THE MARYLAND-NATIONAL CAPITAL PARK AND PLANNING COMMISSION

**MEMORANDUM**

**REVIEW TYPE:** Site Plan Review  
**APPLYING FOR:** Approval of 31 Lots on 71.32 acres  
**PROJECT NAME:** The Estates at Greenbriar Preserve  
**CASE #:** 8-03029

**SITE PLAN**

ESTATES AT  
GREENBRIAR PRESERVE

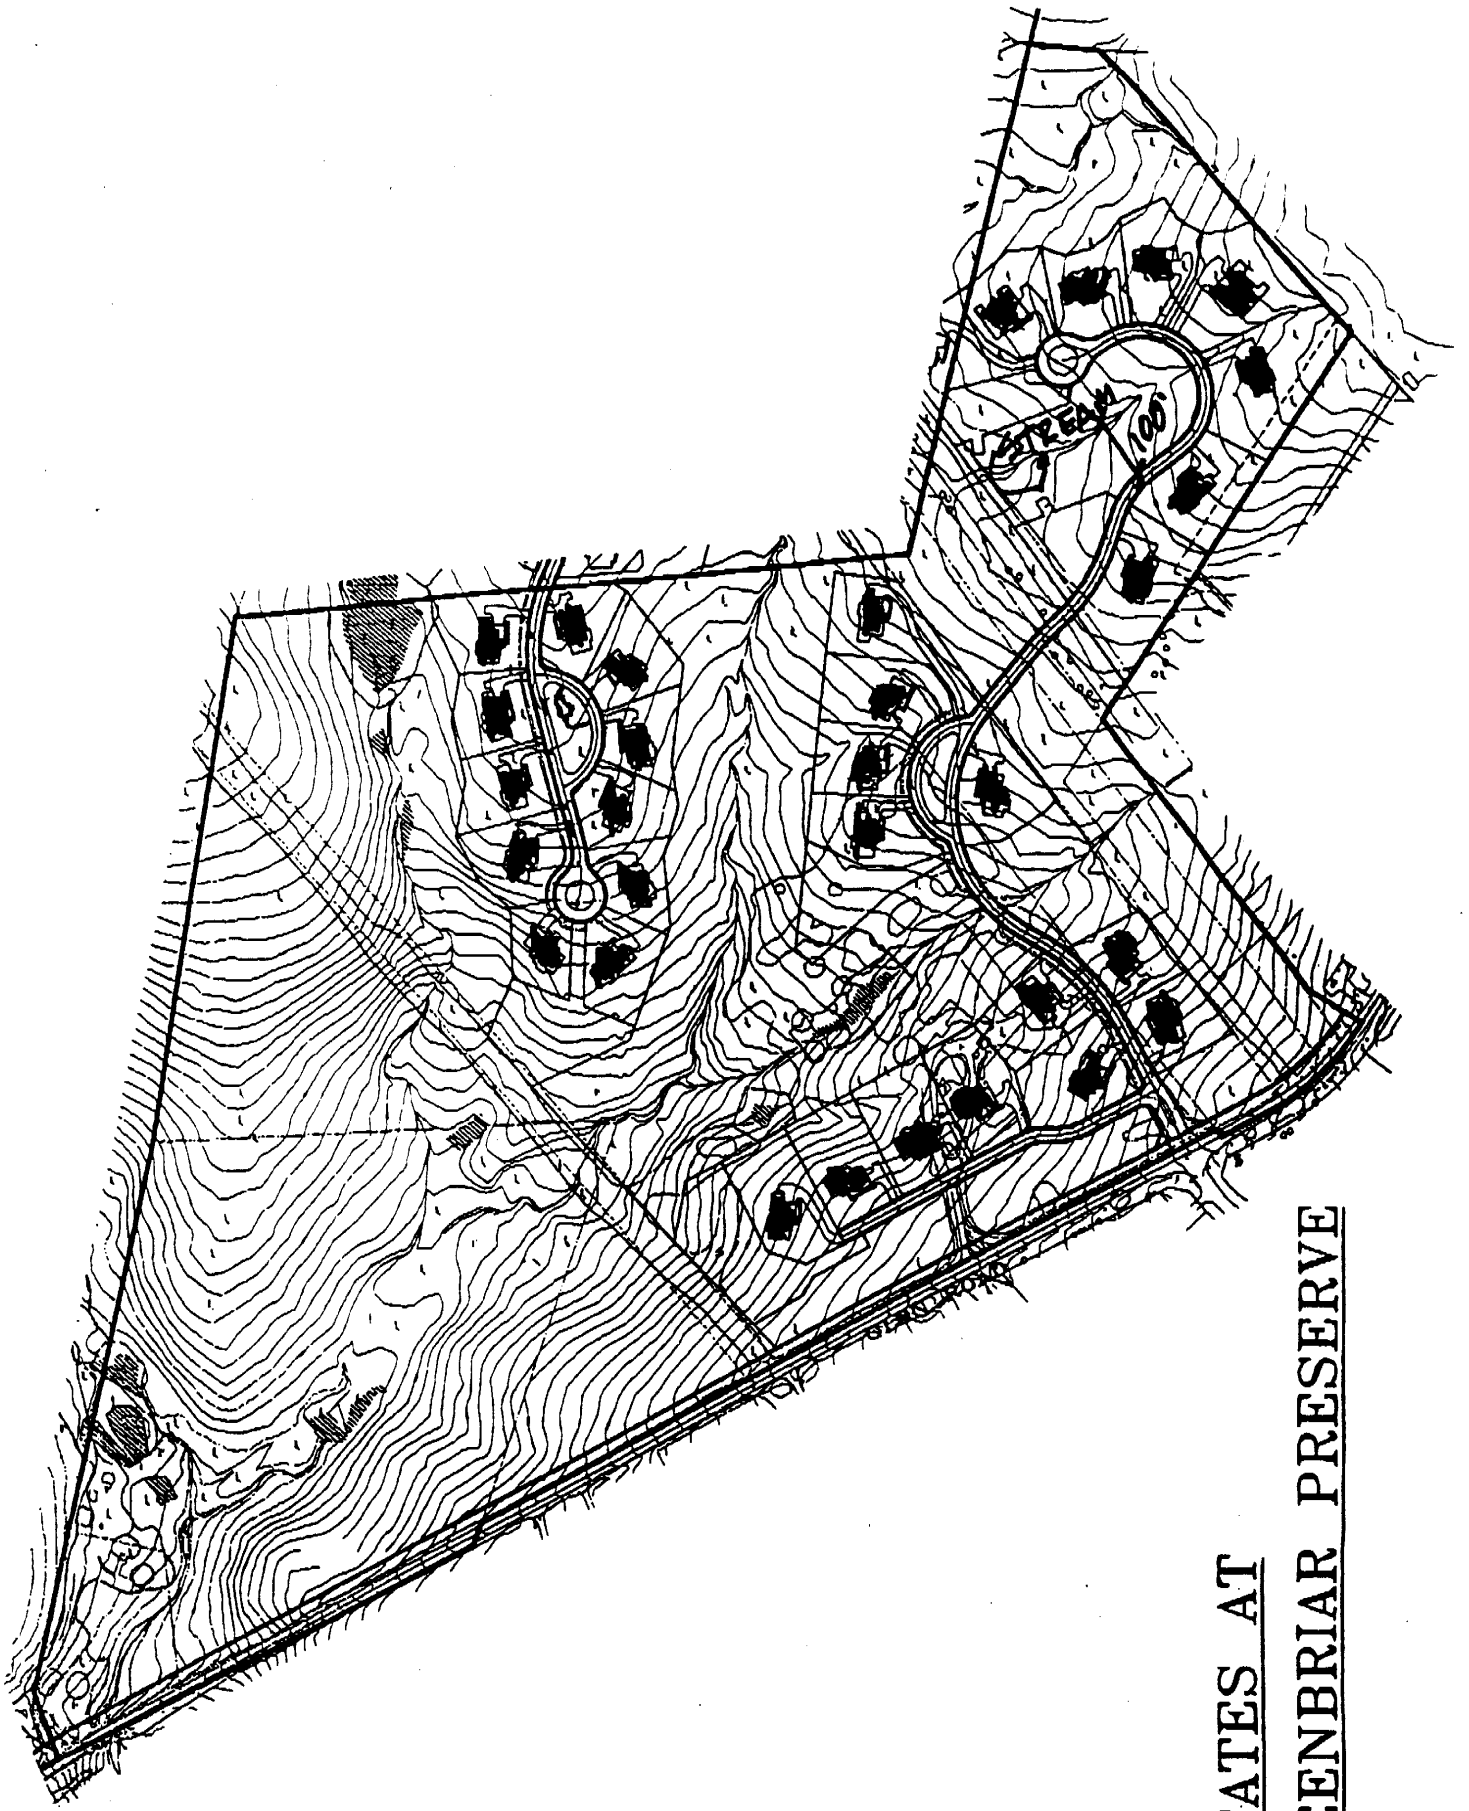
- A. The landscape berm and buffer area shall be added to the rear of lots 3 and 4 to buffer the Reed residence from the views of the adjacent homes. The details of the berm and landscaping shall reflect the proposal for lots 1 and 2 and shall be reviewed by staff. Berms along the utility corridor shall be developed as is feasible per the utility company restrictions.

- B. A fence shall be installed the length of the Johnson's wooded lot. The type of fence shall be either a six foot board on board, three board horse fence or other fence per the requirements of the Johnson's. The fence may be located on the proposed lot or the Johnson's lot as they desire as well.

- C. Applicant to submit, prior to release of signature set, lighting plans to reflect full cut off luminaries with a concealed light source to reduce glare, with no light trespass beyond the site boundaries and light distributions focused on the road and not on the adjoining off - site properties. A point to point photometric grid and light fixture cut sheet shall be submitted for staff review. The lights shall not be located within the underground utility easement area (to reduce visibility) and the lights shall be turned off or reduced in power later in the evening.

- D. The community open space areas shall be revised to provide enhanced public sitting areas with benches, landscaping conducive to defining public spaces and paths to allow for access.

Staff maintains the definition of the stream that was presented to the applicant and citizens at the Site Plan Review Development Review Committee on April 21, 2003. The new plans greatly improves the stream buffer protection and is acceptable to staff as it conforms to the M-NCPPC Environmental Guidelines.

Staff finds the setbacks within the proposed lots and the setbacks within the existing lots to create highly desirable separation of homes. Unit to unit setbacks range from 465 feet to over 600 feet along the rear lots and 285 between the Reed property and the side lots. The presence of preserved and newly planted vegetation, the establishment of the 35 foot buffer to protect off site vegetation from off site impacts and the one-existing to one-proposed lot to lot relationship is an excellent example of compatibility. Staff maintains their recommendation that a Type One FCP easement be placed over the 35 foot buffer to maintain the integrity of the planted area.
